**ADDENDUM NO. 3**  
**GEORGETOWN ELEMENTARY SCHOOL**  
**CLASSROOM & KITCHEN ADDITIONS**  
Georgetown, Delaware 19947

May 27, 2015

The documents for the above referenced project, Project Manual, dated March 2, 2015 and Drawings, dated April 10, 2015, and subsequently issued addenda are amended as follows:

### 6' HIGH TEMPORARY CONSTRUCTION FENCE DETAIL

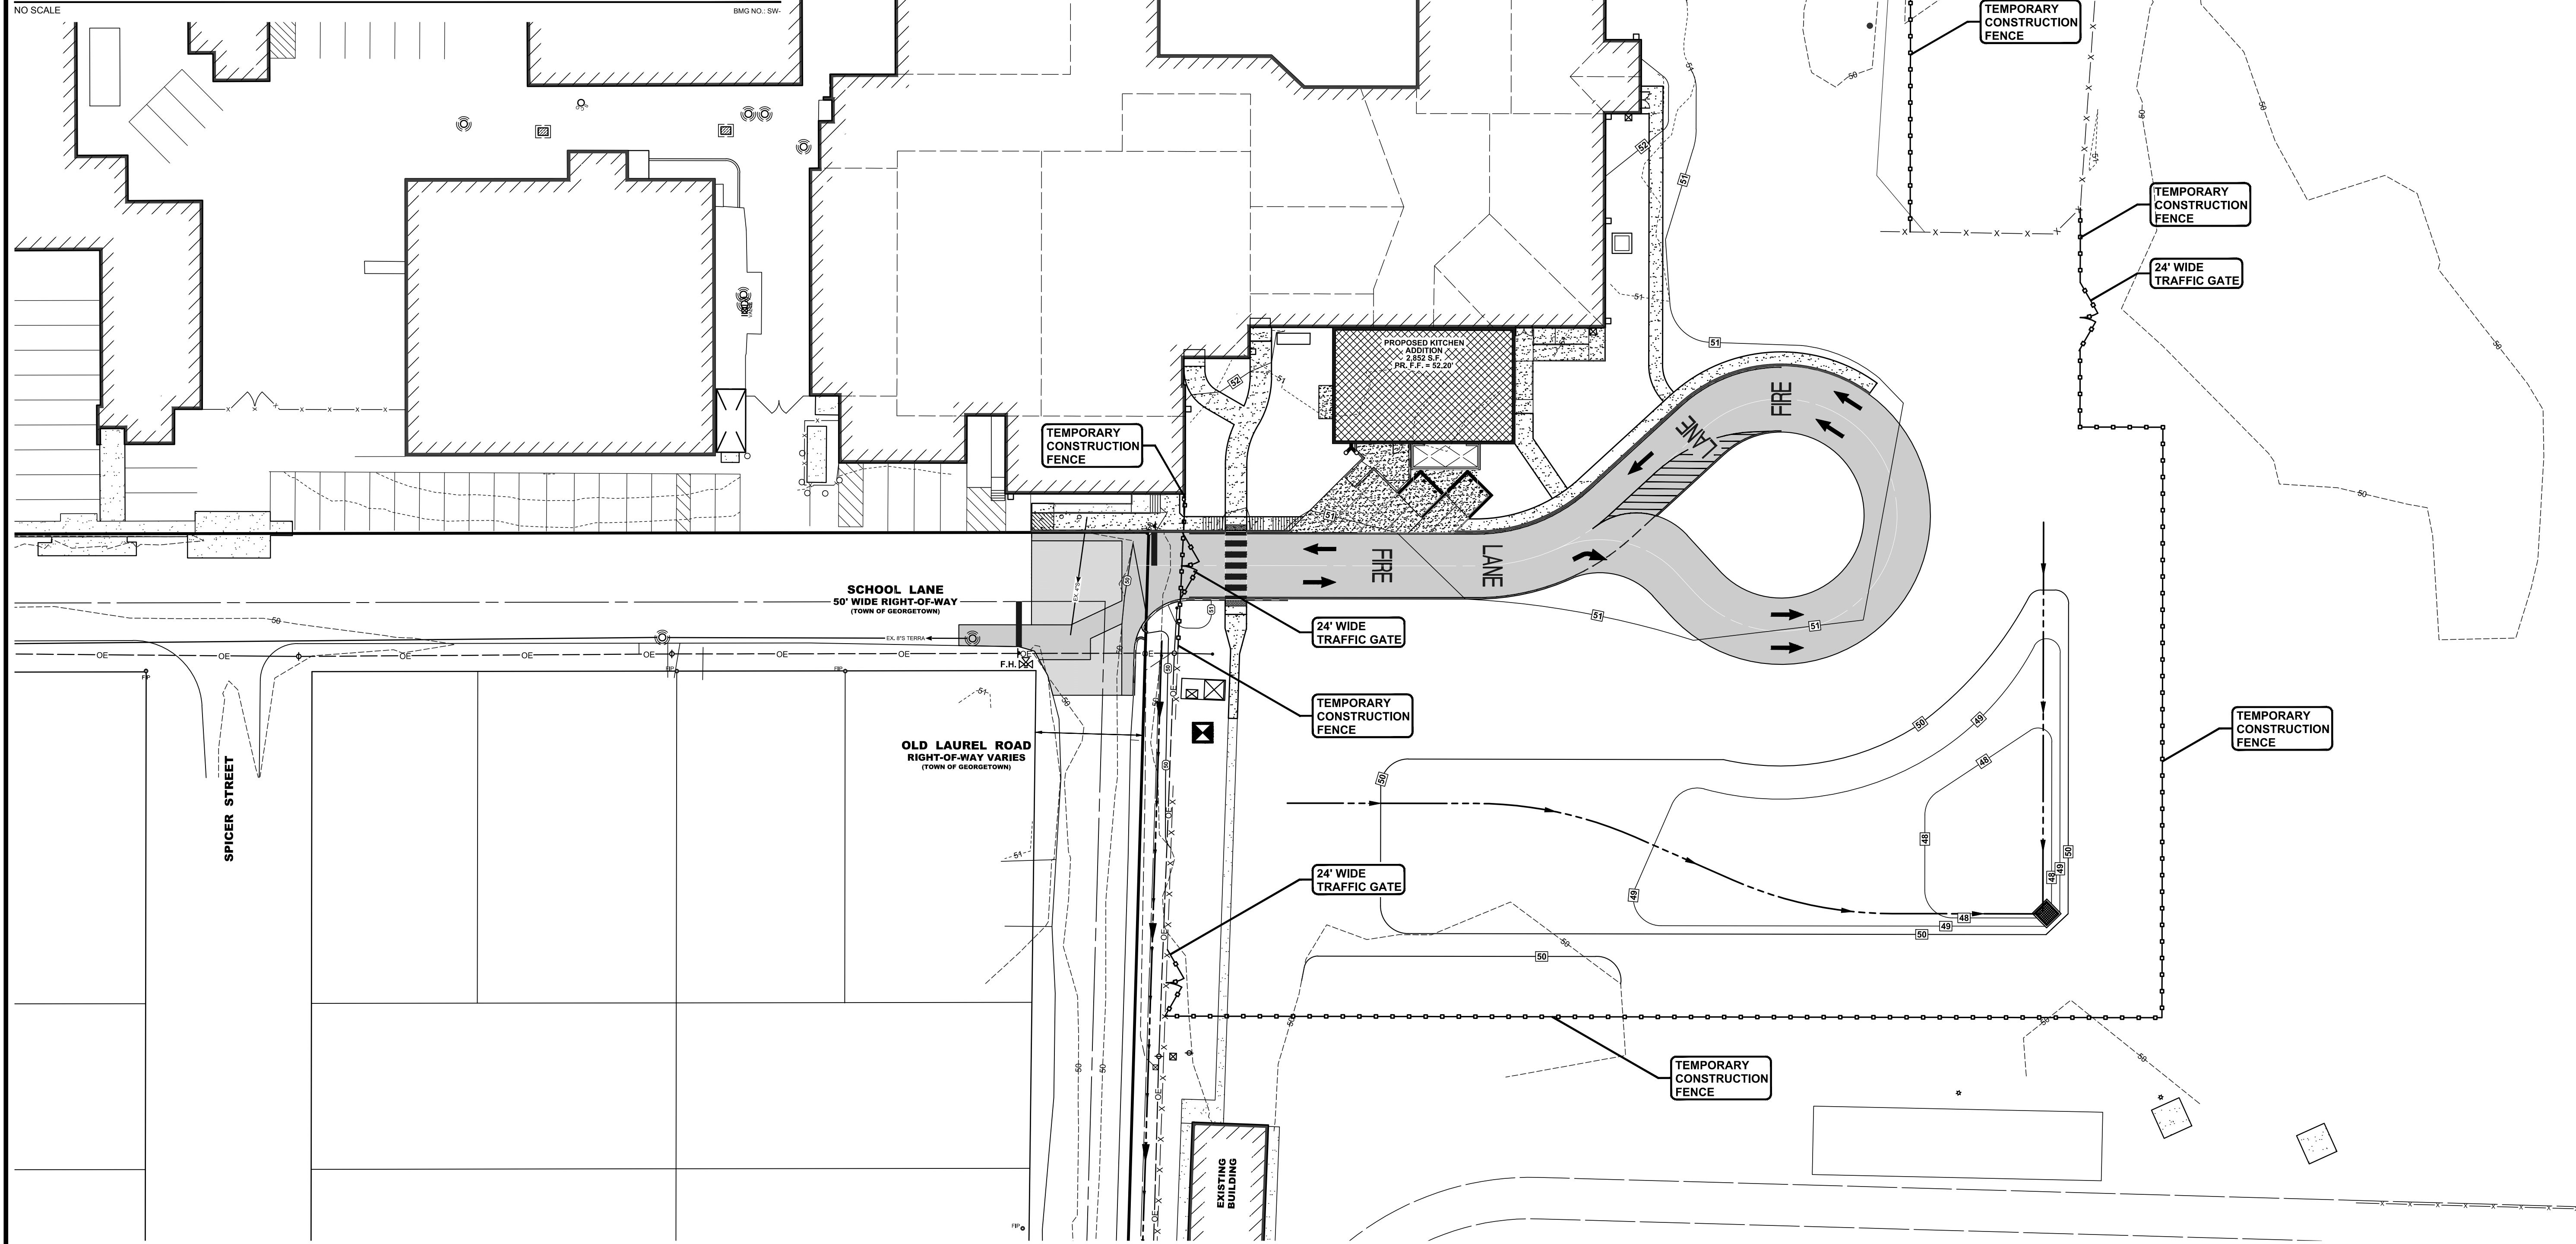
7. See attached sketch for Temporary Construction Fence plan and detail. Final layout and gate locations shall be coordinated in field by Contractor with Construction Manager.

1 KITCHEN ADDITION REFLECTED  
CEILING PLAN

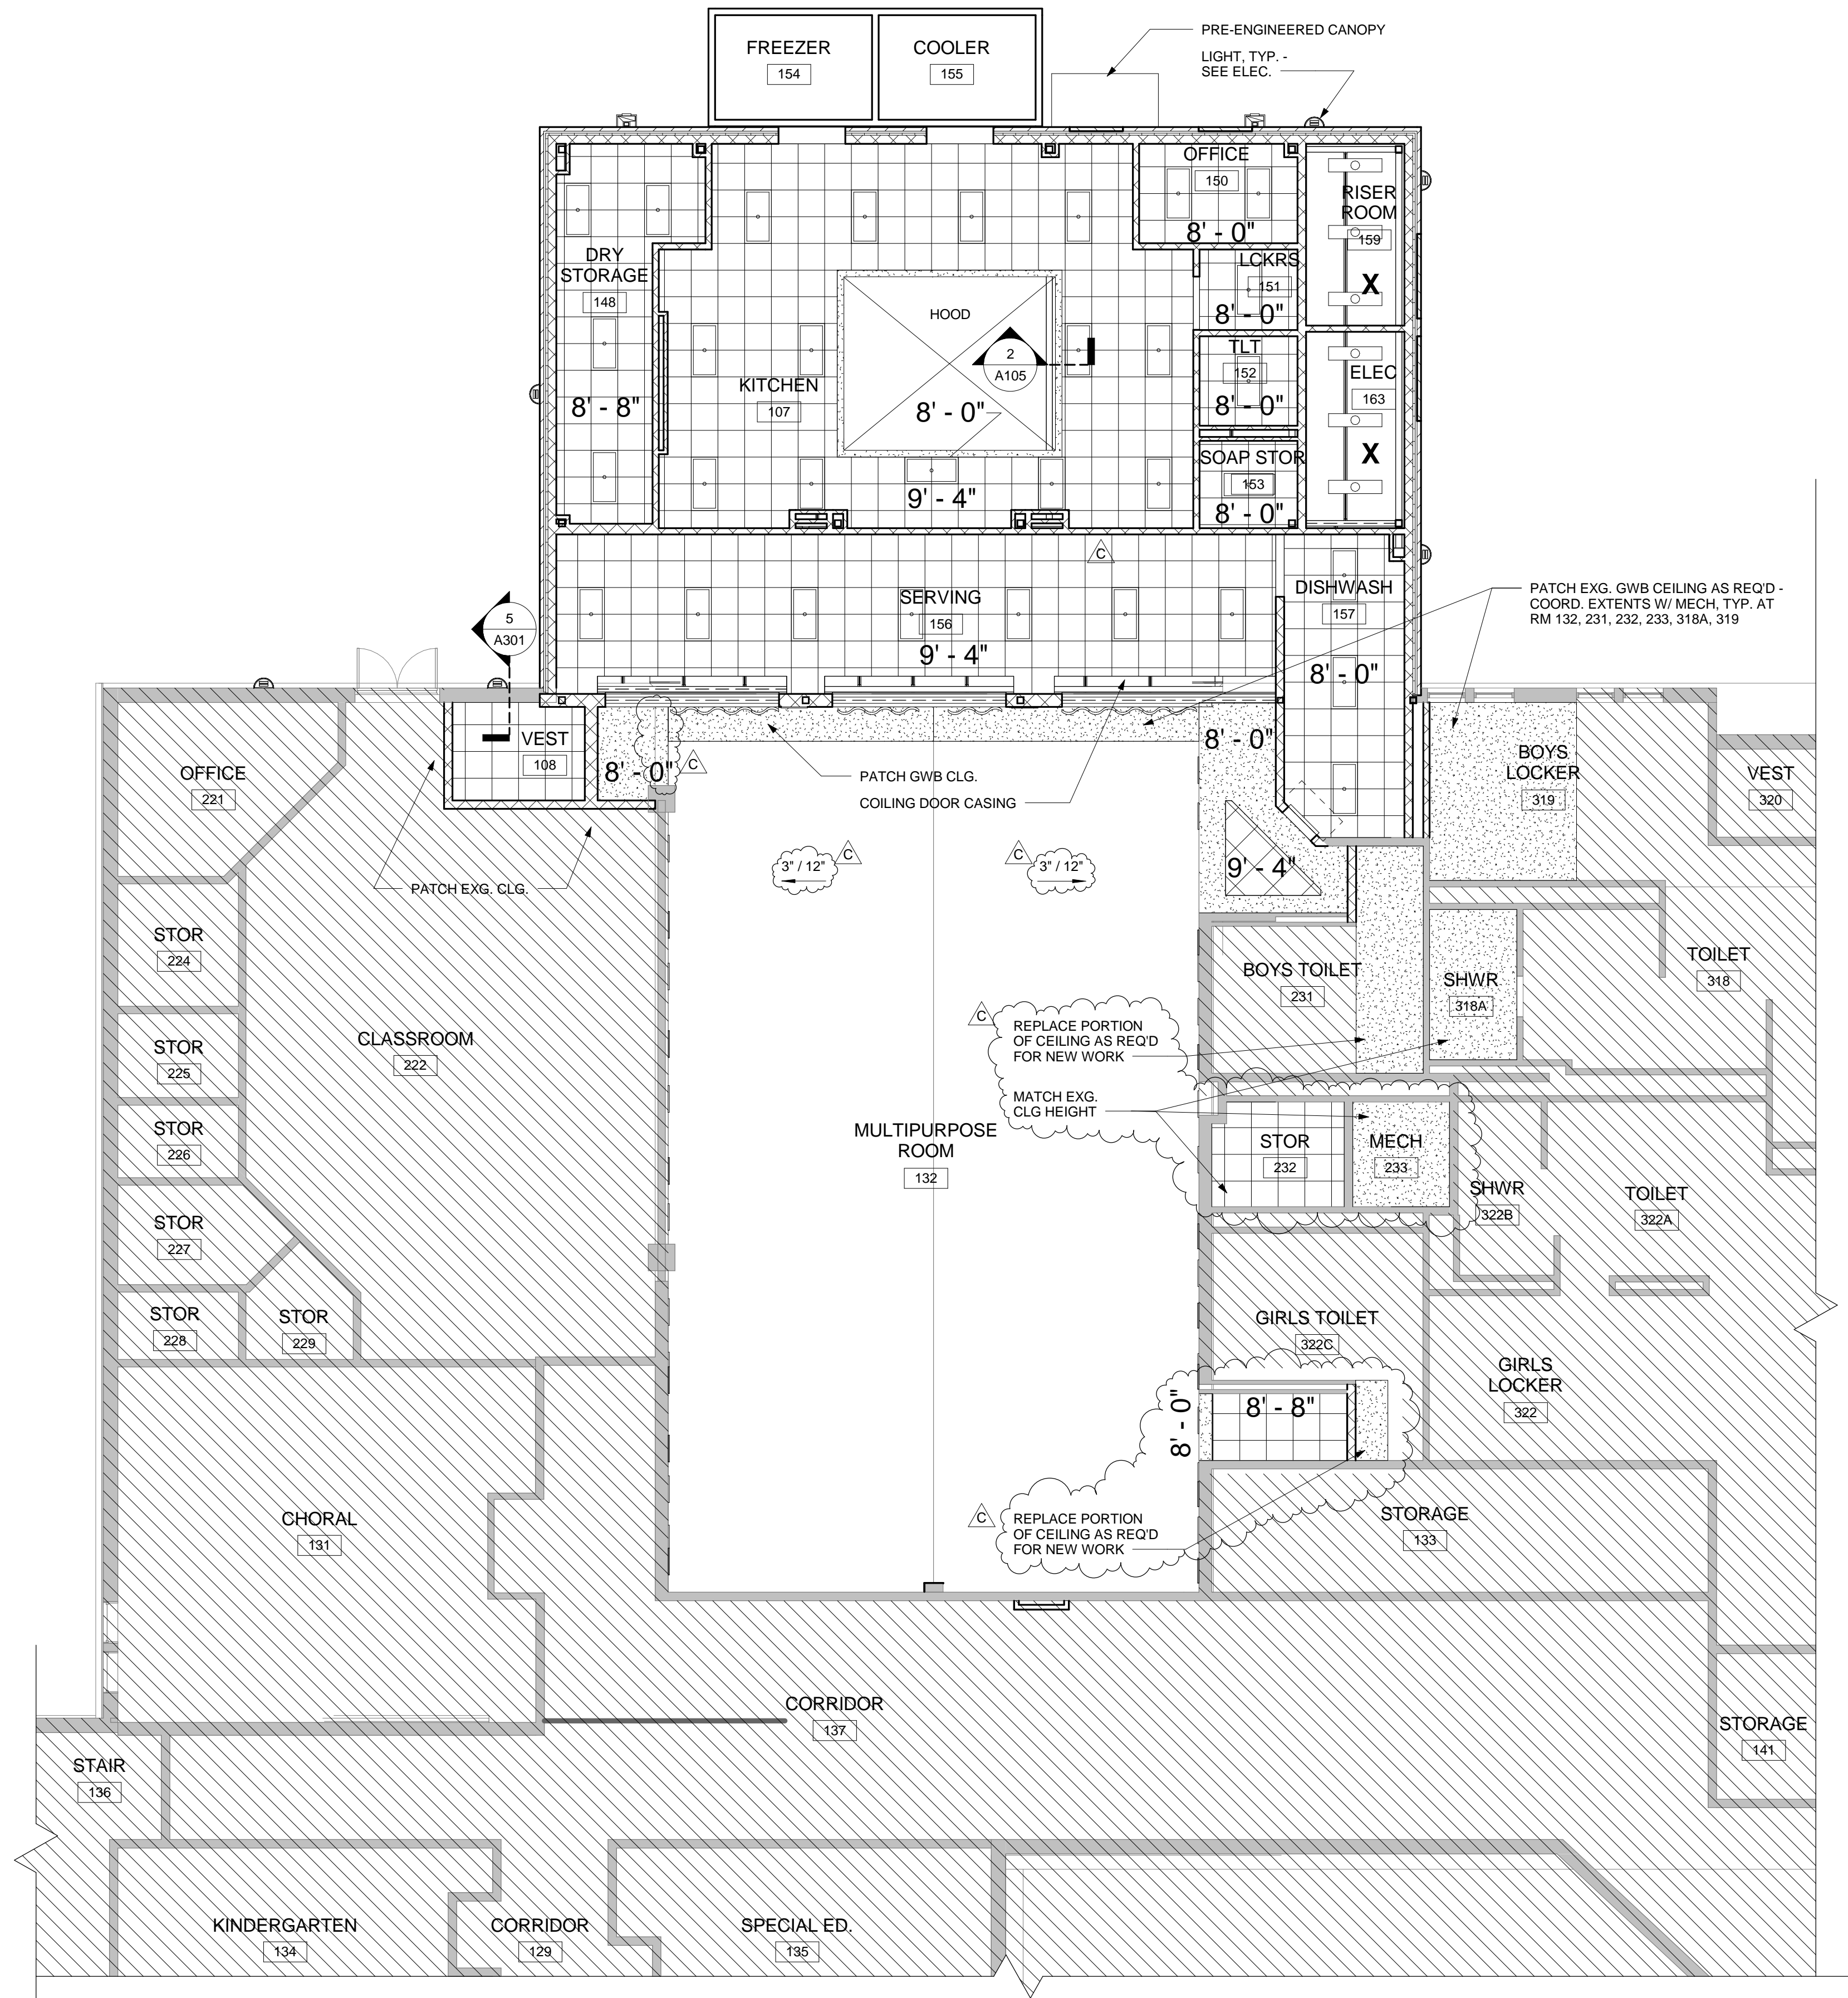
- iii. ADD wall type '1C', at doors 231/1 and 322C/1.
8. A105 Kitchen Addition Reflected Ceiling Plan
  - a. Detail 1: ADD replacement of ceiling at Girl's Toilet 322C vestibule, Storage 232, Mechanical 233, and REMOVE note concerning bond beam at Serving 156.

7 BUILDING SECTION AT MULTI-PURPOSE  
SCALE: 1/8" = 1'-0"

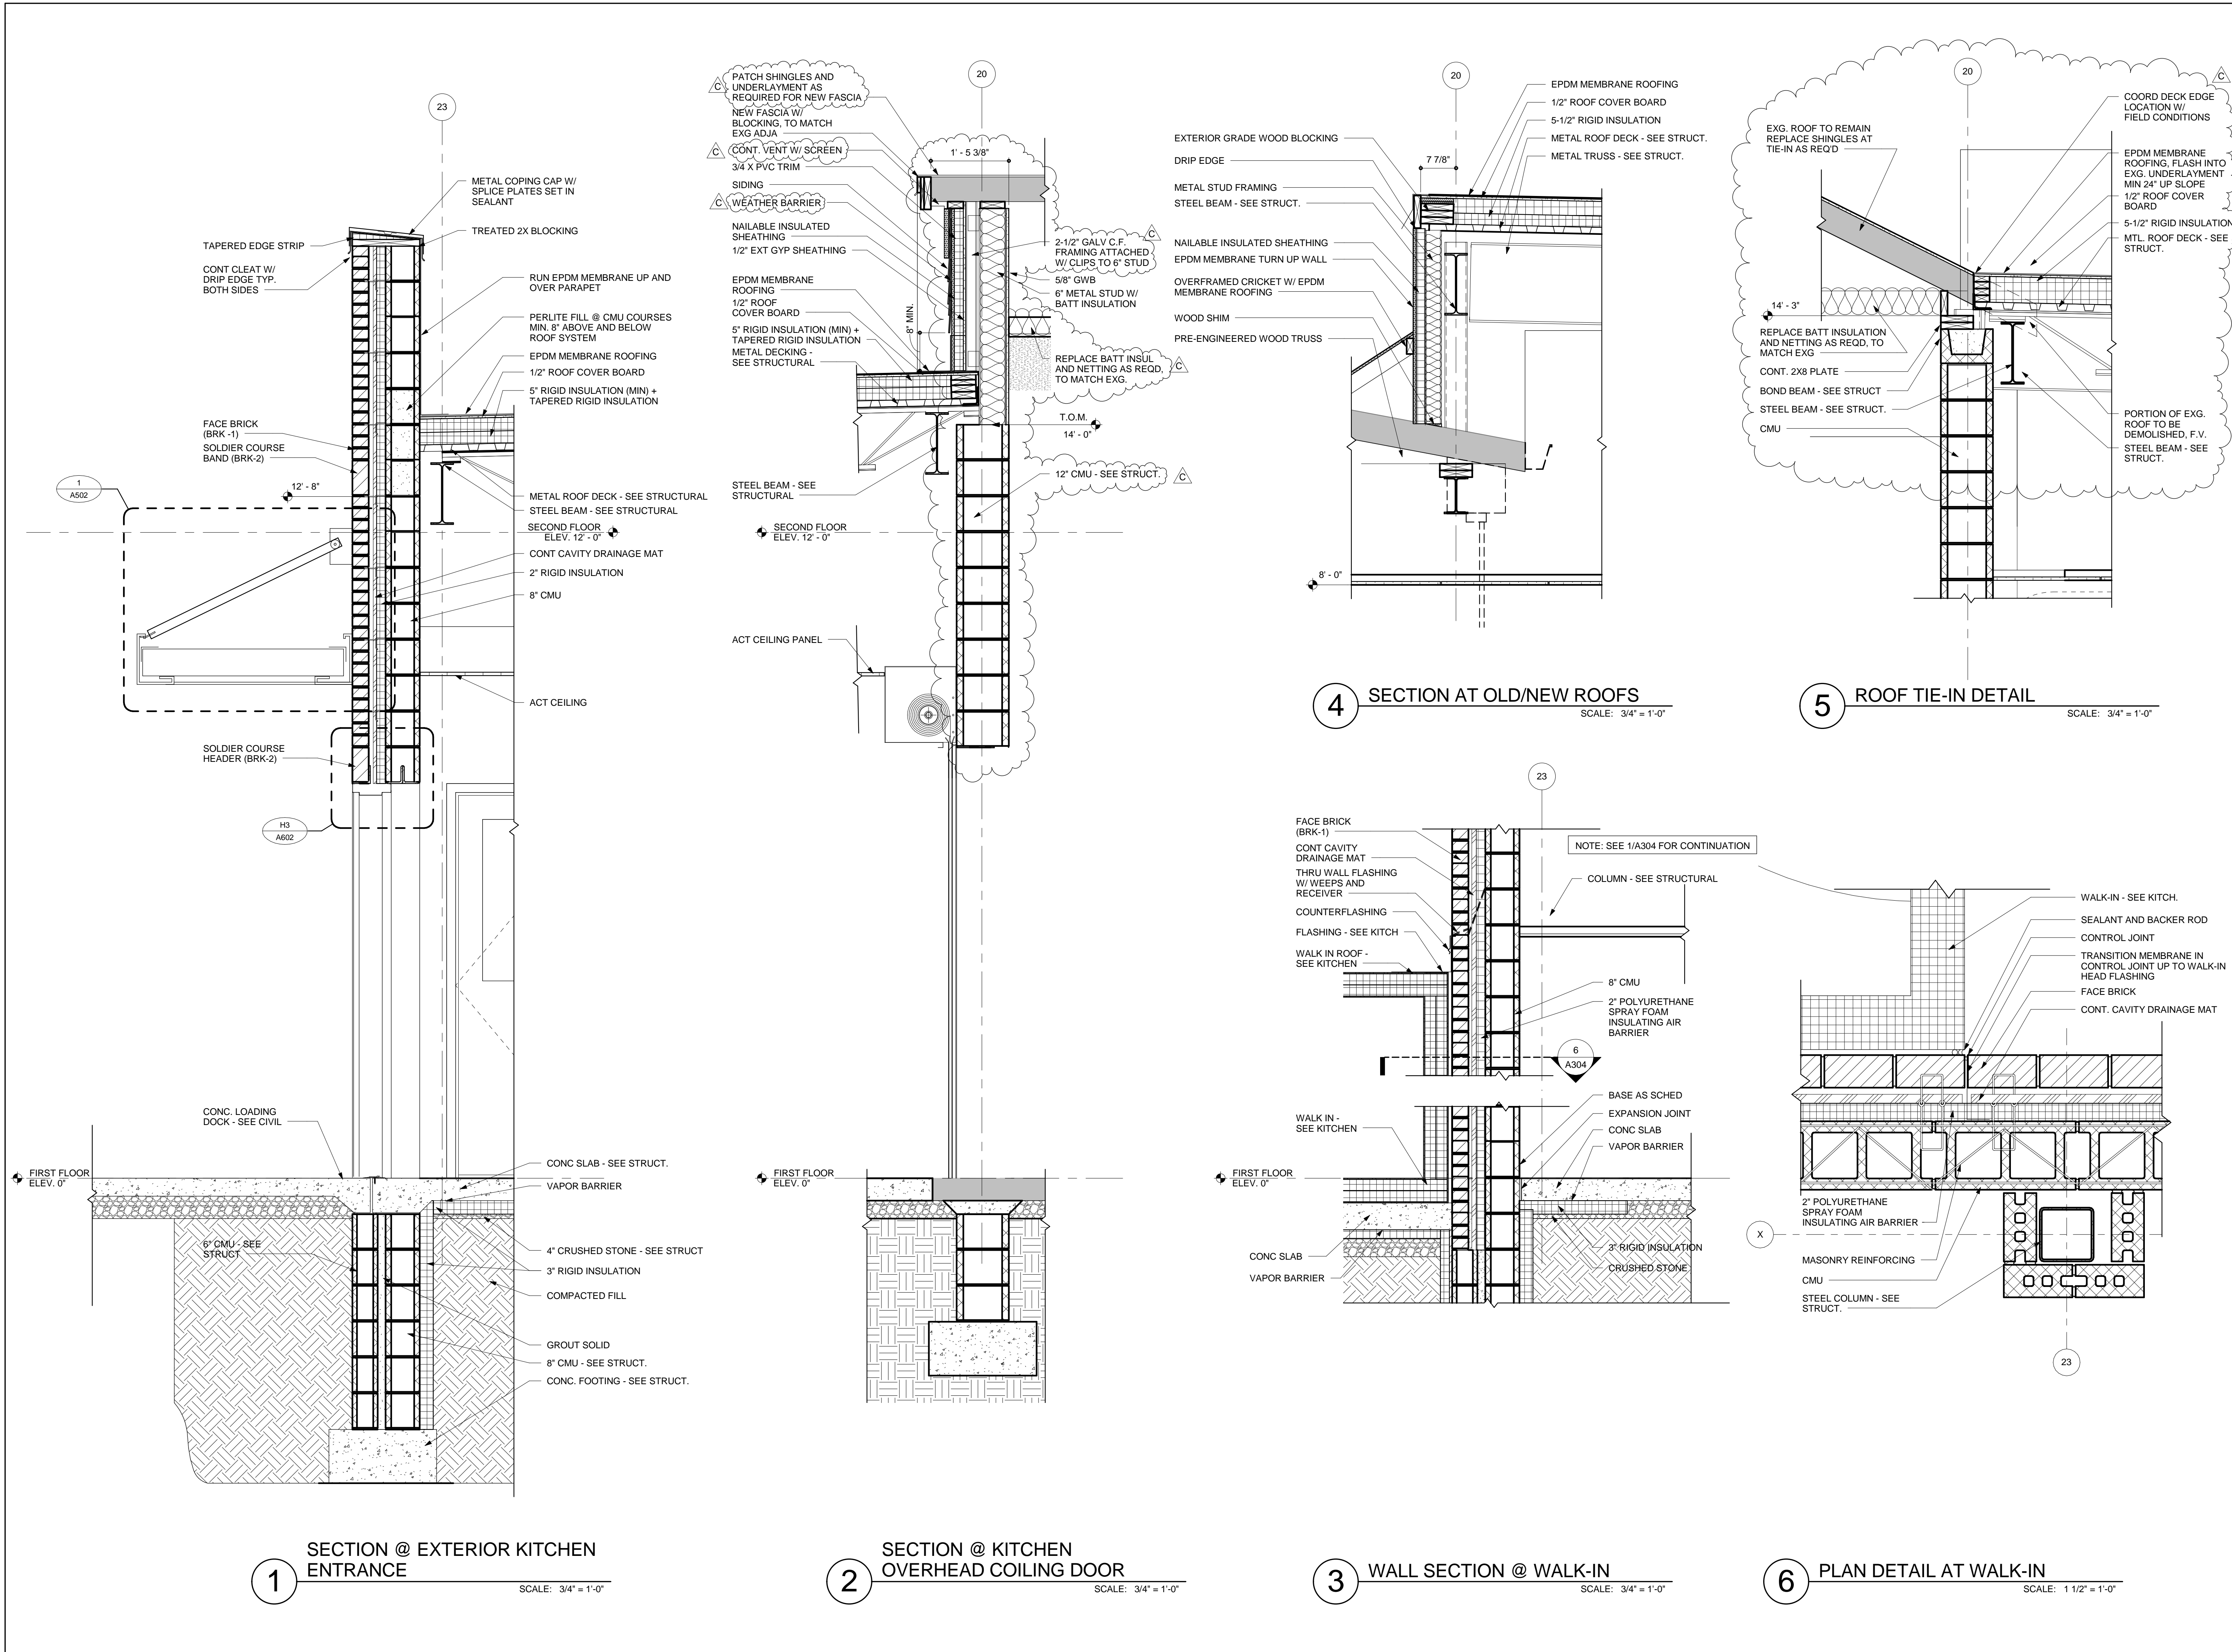
- i. ADD new E.W.C. near gang toilets in Multi-Purpose Room 132, and REMOVE blank detail callout at northeast of Classroom 222.
    - ii. ADD building section 7/A301, cut east-west in Multi-Purpose 132.

11. A301 Building Sections
  - a. ADD Detail 7, per attached drawing.
12. A302 Wall Sections
  - a. Detail 1: REVISE note at roof from " 3/4" FURRING" to "7/8" GALV. HAT CHANNEL".
